PLANNING PROPOSAL – KENTWELL AVENUE, SHOWGROUND ROAD, PENNANT STREET AND CASTLE STREET, CASTLE HILL (3/2023/PLP)

RE: "SITE B" PLANNING PROPOSAL – RESPONSE TO COUNCIL RFI

Reference: Planning Proposal – Kentwell Avenue, Showground Road, Pennant Street and Castle Street, Castle Hill (3/2023/PLP)

Figure 1: Previously Approved Vehicle Access for Retail Expansion overlaid with DA Plans

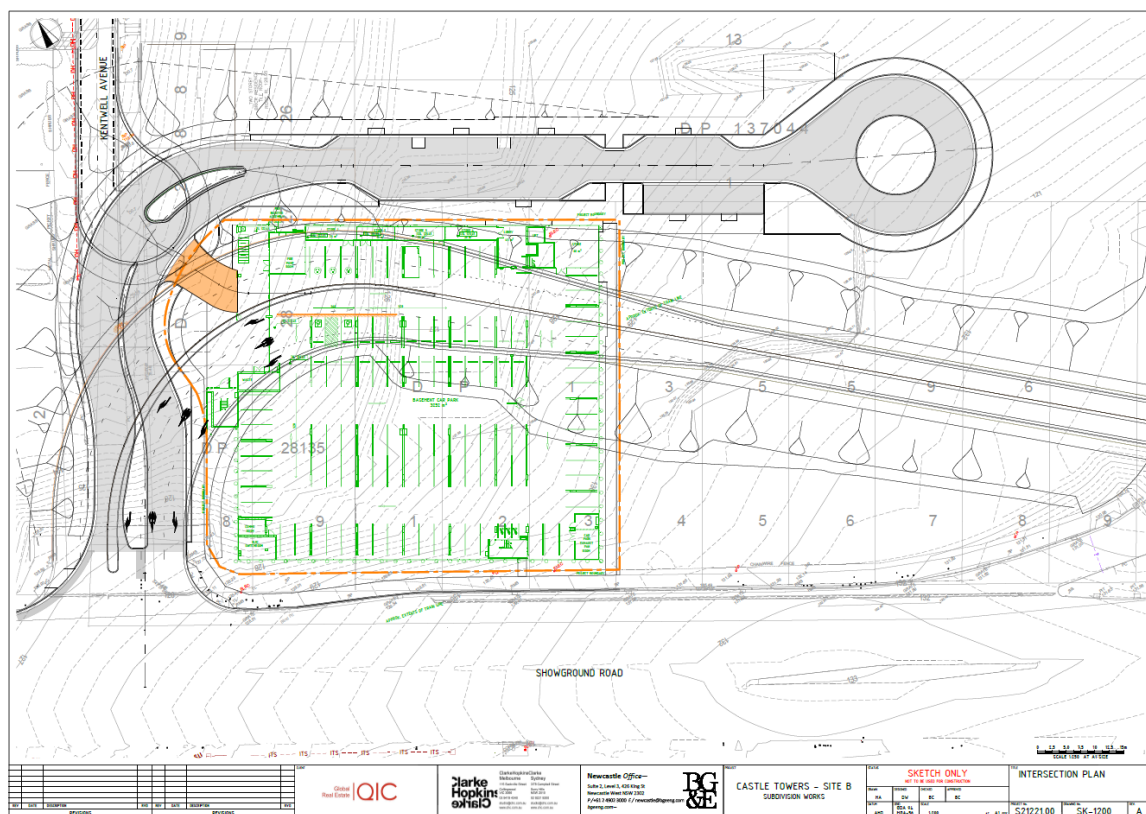
"The planning proposal notes that QIC intends to pursue a development scheme different from that approved under DA 864/2015/JP/B for Castle Towers, with a reduced retail provision. However, it is noted that DA 864/2015/JP has been acted on and as such, cannot be surrendered. A new Development Application for the future plans for Castle Towers has not yet been lodged. As such, there is some uncertainty with respect to the intended outcomes for Castle Towers and the impacts on traffic and transport in the locality. "

From a practice perspective, we also note that the Planning Proposal lodged for “Site B”, as well as the DA submitted for the Woodward Indoor Action Sports Centre on the land, prevents the construction of the required vehicle access through the subject land associated with DA864/2015/JP. That is, it is not possible for the layout proposed under the “Site B” Planning Proposal (or the Woodward DA) to exist in parallel with the approved vehicle access arrangements required under DA864/2015/JP. This conflict is best shown in Figure 1, which overlays the previously approved vehicle access with the Woodward DA layout and illustrates that the two cannot exist at the same time.

1. QIC has confirmed its intent to Council that it will not complete DA864/2015/JP.
2. Advice provided by Ethos Urban in their Response to RFI Report indicates that the DA can be surrendered as per relevant planning legislation.
3. The Planning Proposal lodged by “Site B”, as well as the DA submitted for the Woodward Indoor Action Sports Centre on the land, prevents the construction of the required vehicle access through the subject land associated with DA864/2015/JP.

For the above reasons, it is requested that “Site B” Planning Proposal is reviewed and assessed on its own merit, with the traffic impacts and required infrastructure works reviewed within the context of the traffic expected to be generated by the most up-to-date and current application. In our view, it is neither necessary nor beneficial to assume that the proposed development exists in addition to the development approved under DA864/2015/JP as this simply cannot physically occur.

Figure 2: Showground Road / Kentwell Avenue Intersection – Proposed Design

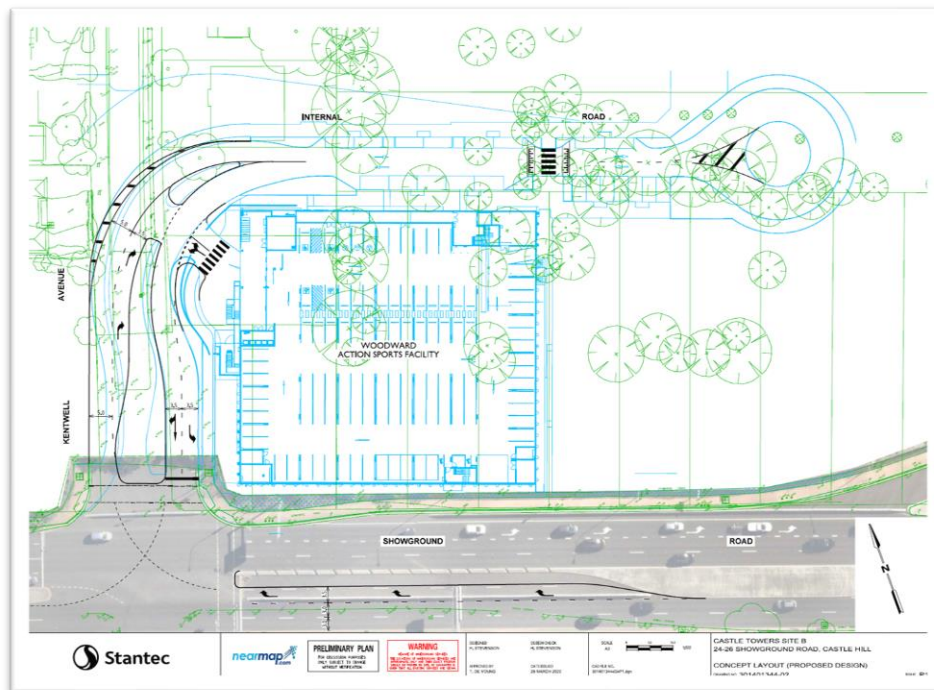
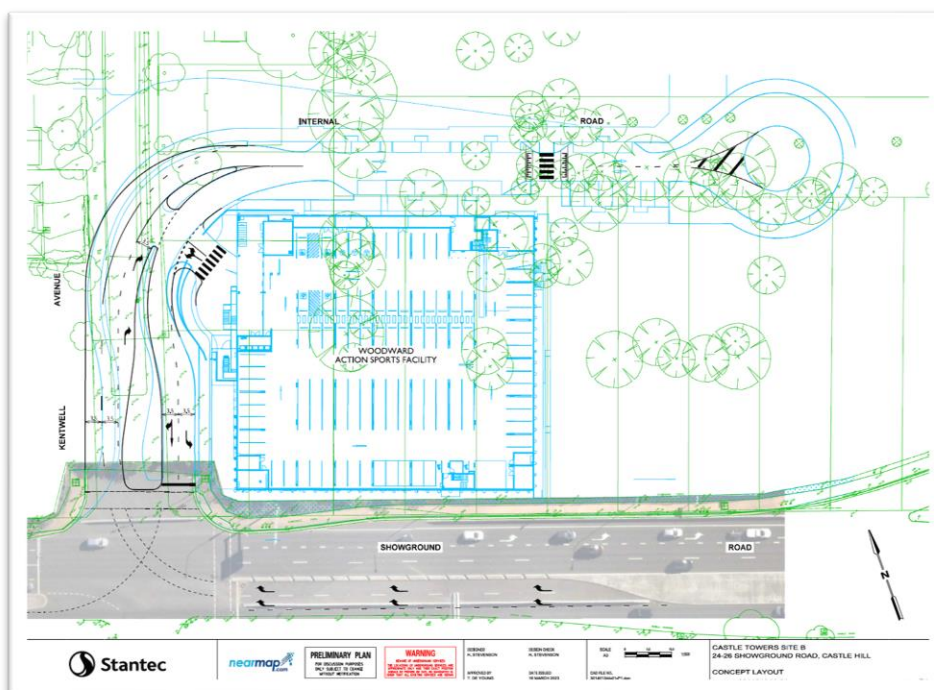
“The planning proposal and traffic report indicate that the change in outcomes will significantly reduce vehicle trip generation in Castle Hill, compared to the existing approval. While this may be the case, a number of traffic upgrades that have been previously identified are still required, including dual right turn lanes from Showground Road into Kentwell Avenue and upgrades to the Castle Street/Pennant Street intersection to include dual departure lane on Castle Street.”

Notwithstanding this, after further consideration of TfNSW and Council's position, QIC has agreed to amend the proposed design for the intersection to better allow for the second entry lane (or indeed even a third exit lane) to be provided in the future, should it be deemed necessary for the Site B Planning Proposal or its associated development applications. This future proofing has been achieved by ensuring that the new internal access road matches the existing constructed width of the Kentwell Avenue stub at Showground Road and then "filling" the middle of that existing width with landscaping rather than traffic lanes. This allows for the middle section of the internal access road width to be used for additional lanes in the future if it is proven to be required for traffic capacity reasons.

For reference, the proposed and potential future designs of this intersection are shown in Figures 2 and 3 below. It is emphasised that the design in Figure 2 is to be provided as part of the proposed Woodward development and TfNSW and Council approval is sought for this layout. In comparison, the design shown in Figure 3 is presented solely to illustrate that the proposed design could be widened to provide two entry lanes if required in the future.

Overall, we reiterate the views outlined above that a larger intersection layout should not be considered necessary at the Showground Road / Kentwell Avenue intersection for the revised development proposed on Site B. This is supported by traffic analysis submitted previously to Council and TfNSW.

Figure 4: Proposed Castle Street / Pennant Street Design

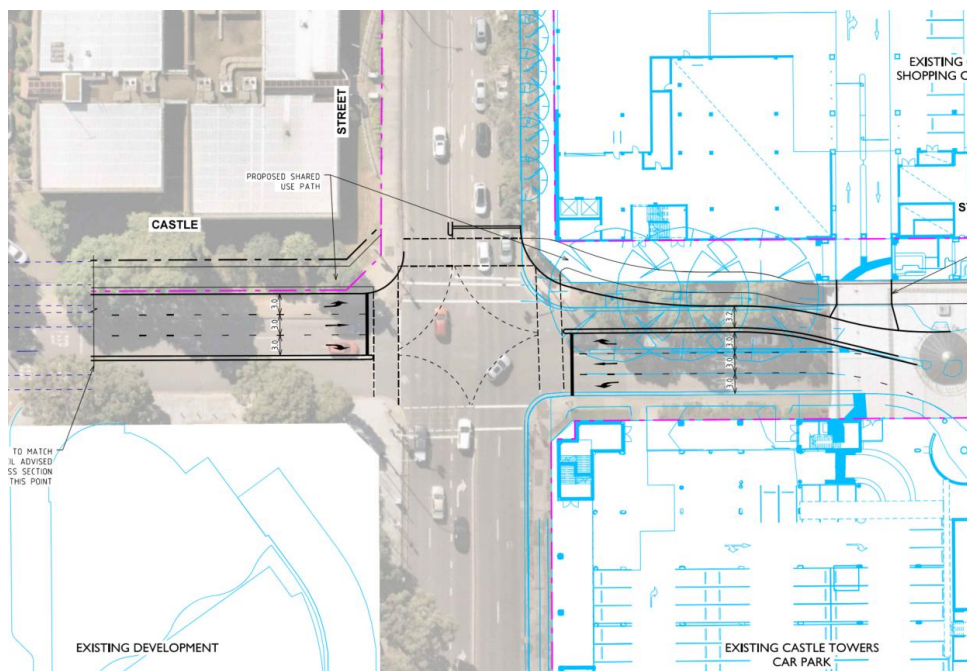
It is understood that Council and TfNSW are currently considering the completion of works at this intersection to improve its safety and operation. The works proposed are to enable 'double diamond' traffic signal phasing at the intersection and thus remove filtered right turns. This phasing requires separate right-turn lanes on the Castle Street approaches.

Assuming works are required at the intersection, we recommend the layout as shown in Figure 4. This layout is included in the TIA prepared for the Site B Planning Proposal and we believe it leads to the best "on balance" design outcome. Ultimately though, we note that the Planning Proposal does not impact the final decision made with respect to the layout at this intersection,

Figure 2: Showground Road / Kentwell Avenue Intersection – Proposed Design

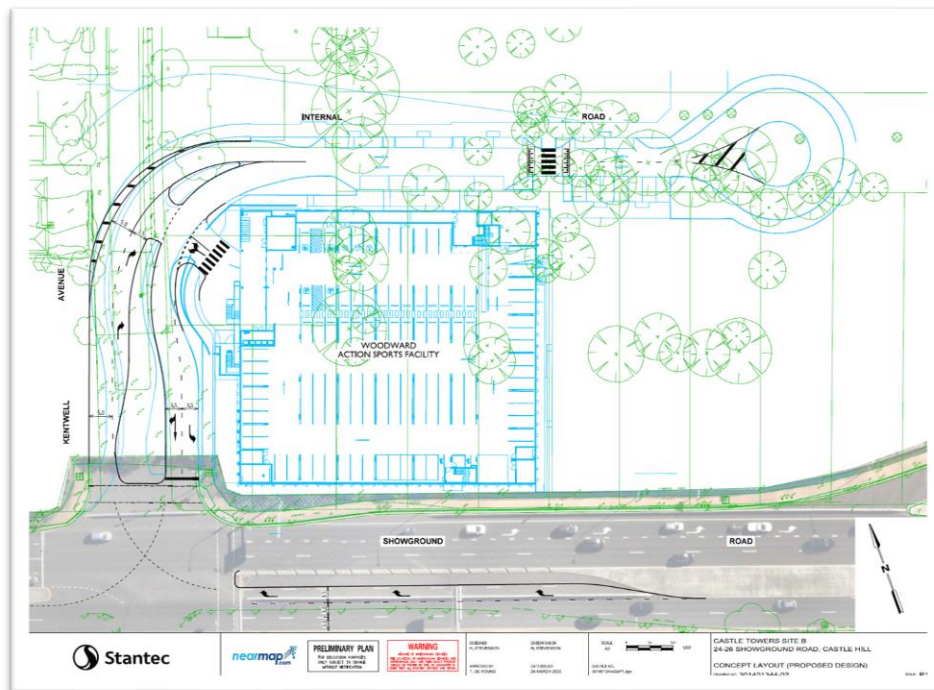
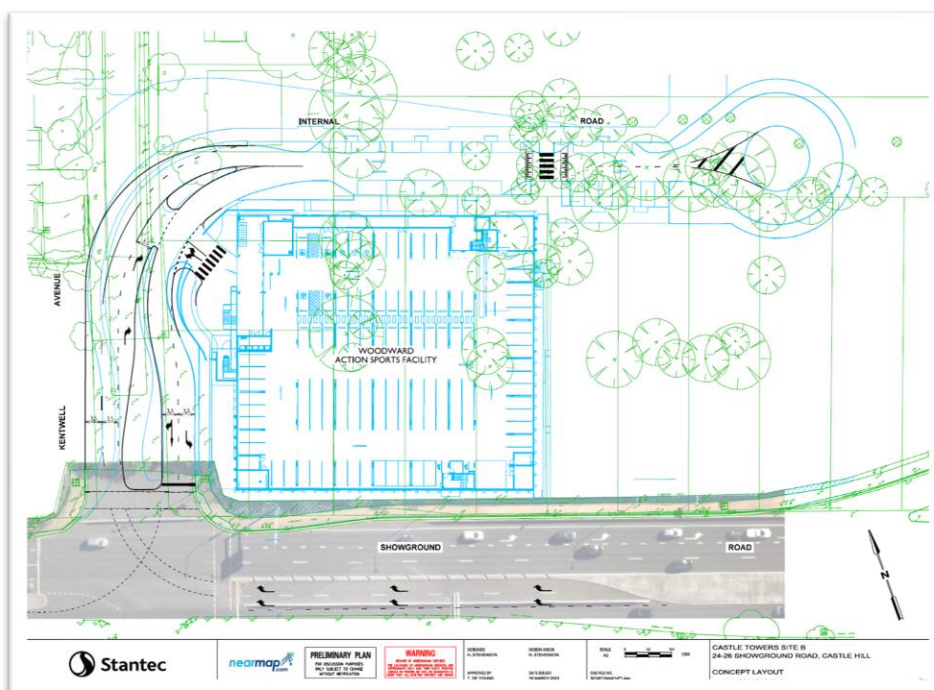
“The planning proposal and traffic report indicate that the change in outcomes will significantly reduce vehicle trip generation in Castle Hill, compared to the existing approval. While this may be the case, a number of traffic upgrades that have been previously identified are still required, including dual right turn lanes from Showground Road into Kentwell Avenue and upgrades to the Castle Street/Pennant Street intersection to include dual departure lane on Castle Street.”

For reference, the proposed and potential future designs of this intersection are shown in Figures 2 and 3 below. It is emphasised that the design in Figure 2 is to be provided as part of the proposed Woodward development and TfNSW and Council approval is sought for this layout. In comparison, the design shown in Figure 3 is presented solely to illustrate that the proposed design could be widened to provide two entry lanes if required in the future.

Figure 4: Proposed Castle Street / Pennant Street Design

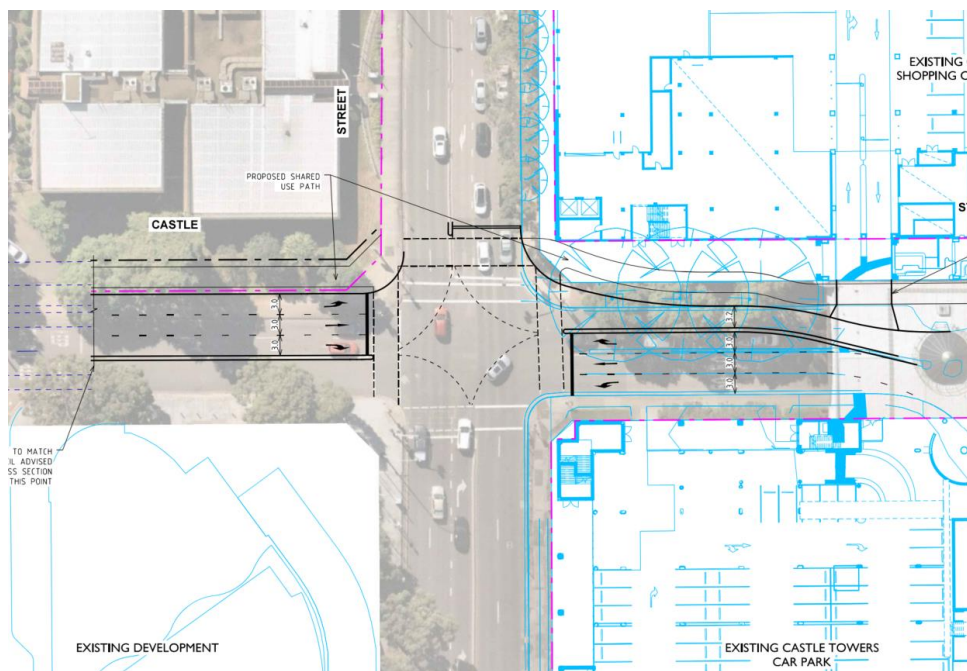
It is understood that Council and TfNSW are currently considering the completion of works at this intersection to improve its safety and operation. The works proposed are to enable 'double diamond' traffic signal phasing at the intersection and thus remove filtered right turns. This phasing requires separate right-turn lanes on the Castle Street approaches.

Assuming works are required at the intersection, we recommend the layout as shown in Figure 4. This layout is included in the TIA prepared for the Site B Planning Proposal and we believe it leads to the best "on balance" design outcome. Ultimately though, we note that the Planning Proposal does not impact the final decision made with respect to the layout at this intersection,

Figure 1 – Showground Road / Kentwell Ave (Future Intersection Configuration)

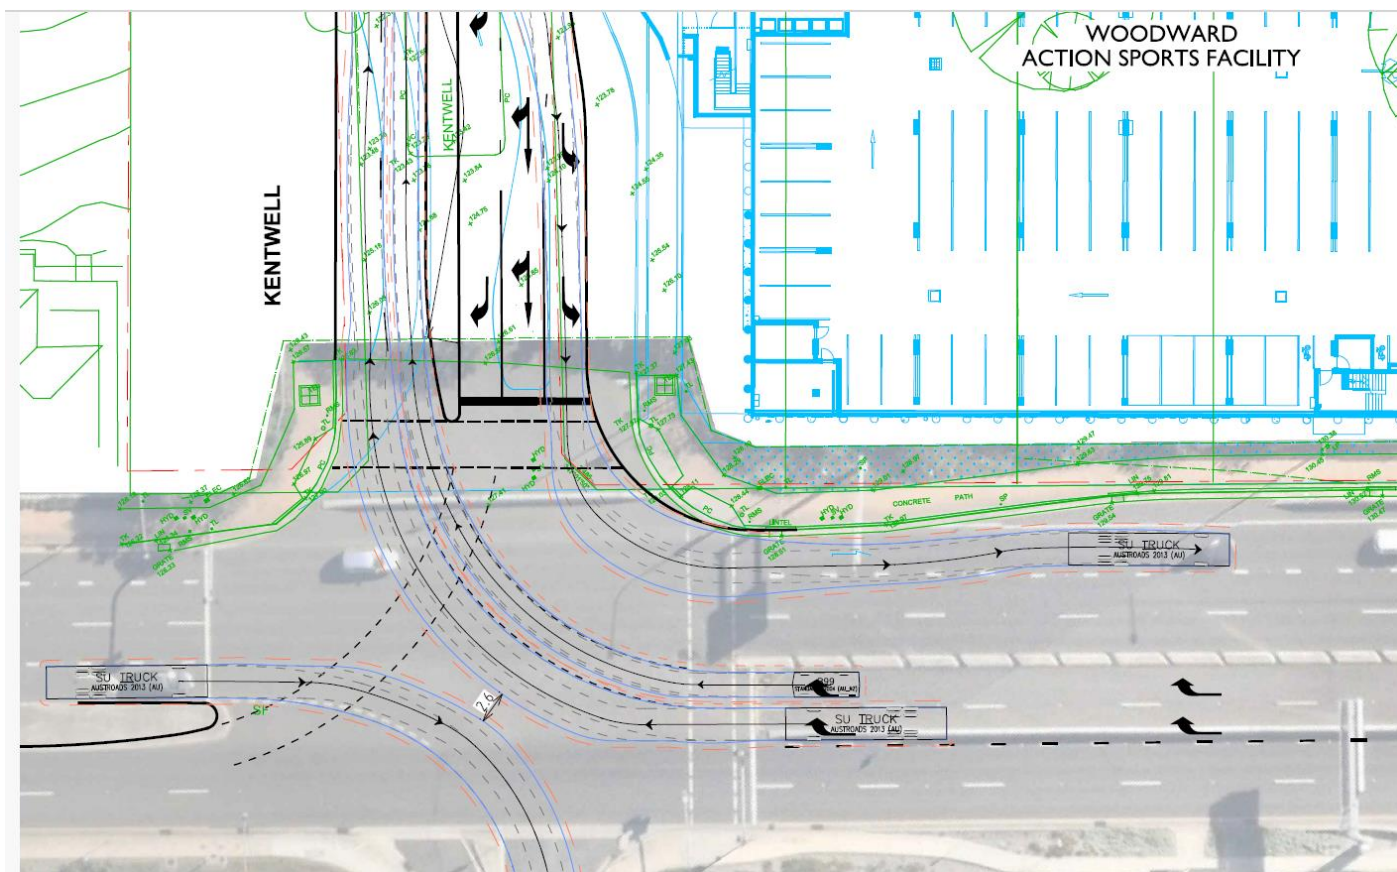
However, on the 12 February 2024, Stantec had prepared a letter “Project No: 301401344” which is titled “24-28 Showground Road & 1-5A Kentwell Avenue, Castle Hill – Proposed Indoor Action Sports Centre – Response to Council RFI” which highlighted outcomes from discussions with TfNSW of the need to ensure that development and planning in and around this intersection facilitates the future provision of 3-approach and 2-departure lanes on the Kentwell Avenue leg of this intersection. See **Figure 1** on the following page.

Therefore, any plans, setbacks, etc associated with this planning proposal must ensure that the future provision of 3-approach and 2-departure lanes on the Kentwell Avenue leg of this intersection are suitably addressed.

Figure 2 – Initially Proposed Concept Layout (Source: Stantec TIAR for Planning Proposal)

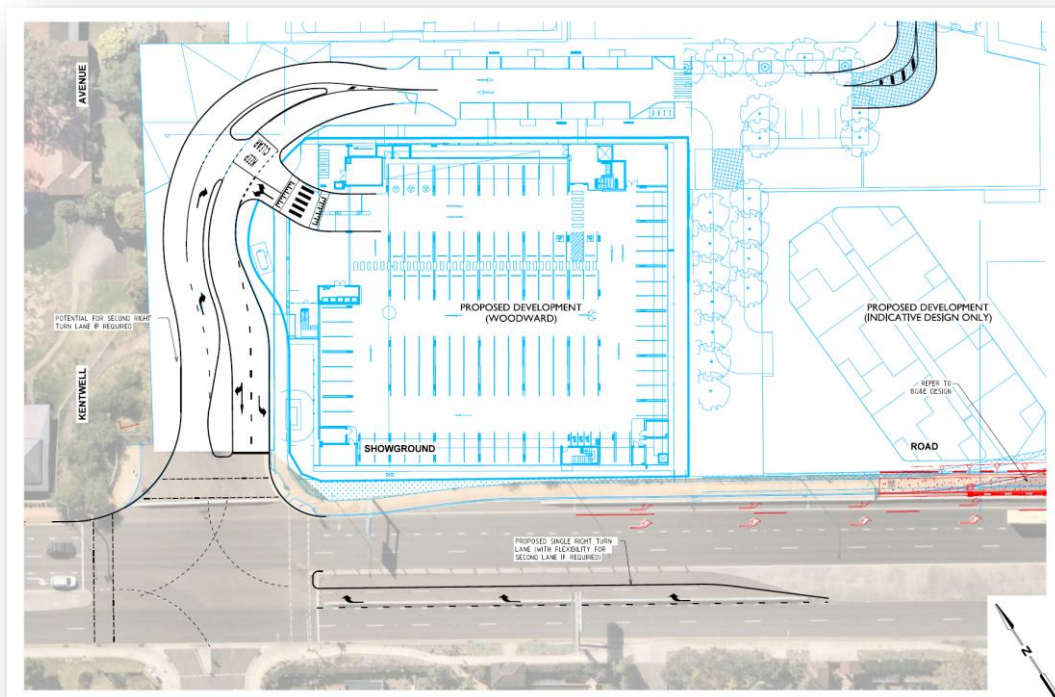
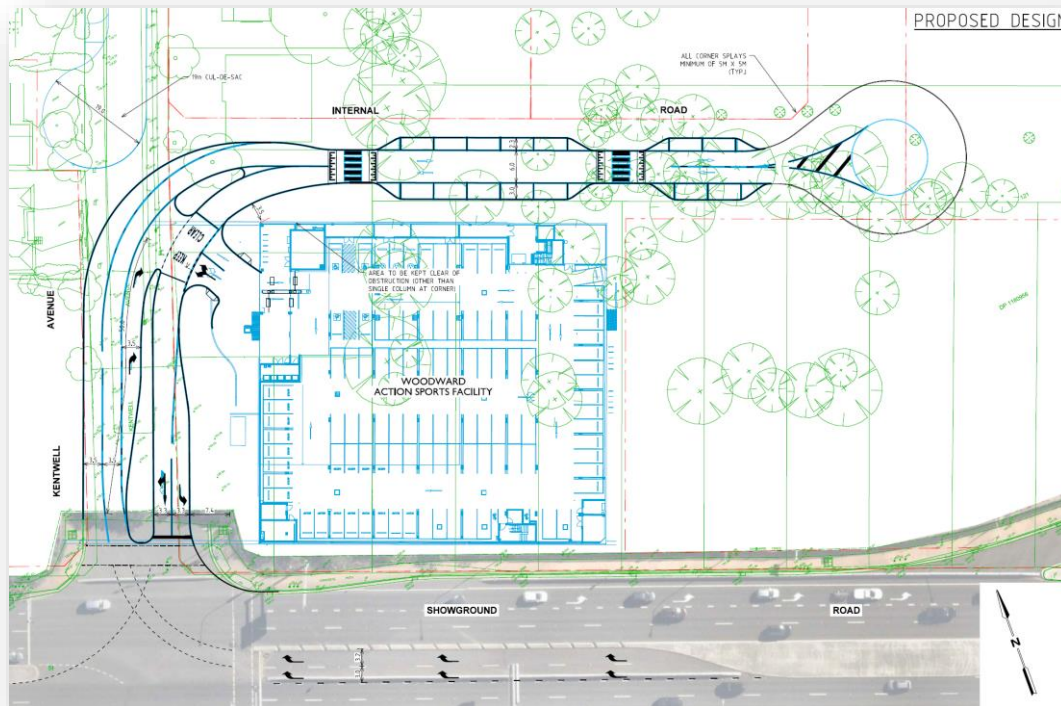
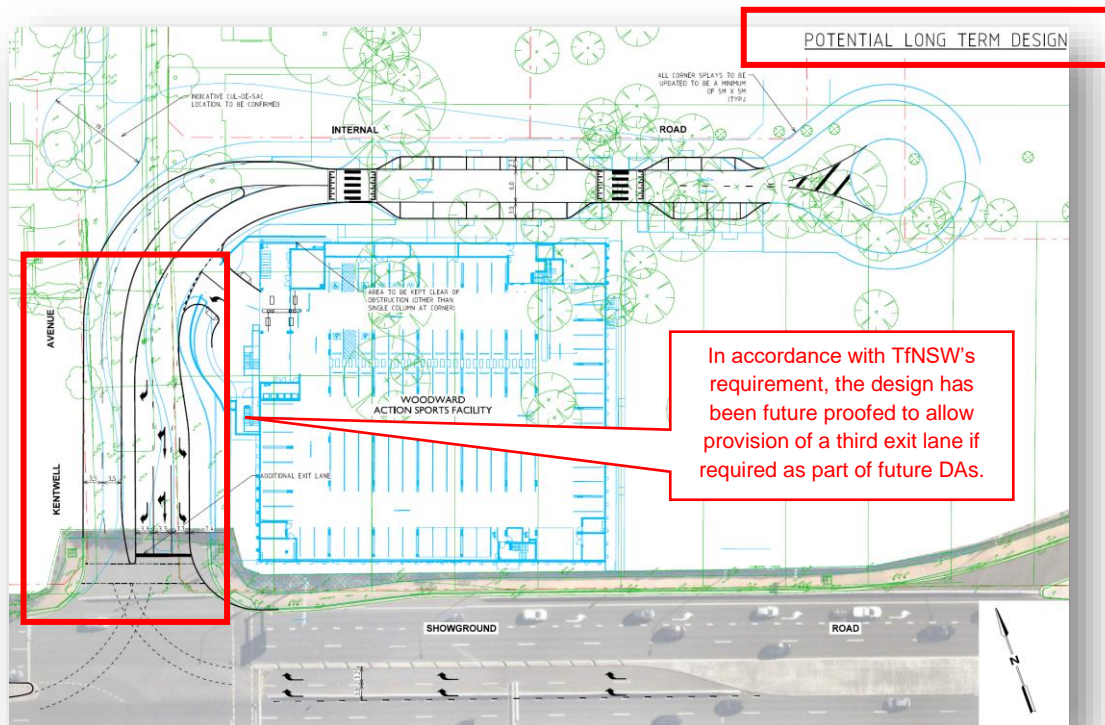
The concept layout plan for the Showgrounds Road / Kentwell Avenue intersection that was included in the August 2022 TIAR for the Planning Proposal was prepared in June 2022. At that time, it was proposed that the intersection would be configured with one entry lane and two exit lanes given greater traffic capacity was not required due to the “traffic de-intensification” of the site i.e., moving away from a major retail development to a residential development. This intersection layout proposed at that time is shown in Figure 2 over page.

The agreement to the modified intersection layout was confirmed in a letter prepared by Stantec dated 12 February 2024. This Stantec letter included concept plans for the proposed layout (two entry and two exit lanes) and the potential long-term / ultimate layout (two entry and three exit lanes). These plans are reproduced in this letter in Figures 3 and 4, respectively. The two concept plans show that the total width of the vehicle access to/from Site B does not alter in the two options; rather, the third lane out of the site is simply created via conversion of the central median into a trafficable lane.

Overall, I confirm that the intersection has been designed to accord with TfNSW's requirements and this is confirmed in the architectural plans for the approved Woodward DA. As such, I consider this a matter that can be addressed after the Gateway determination via a minor revision to the Planning Proposal documentation.
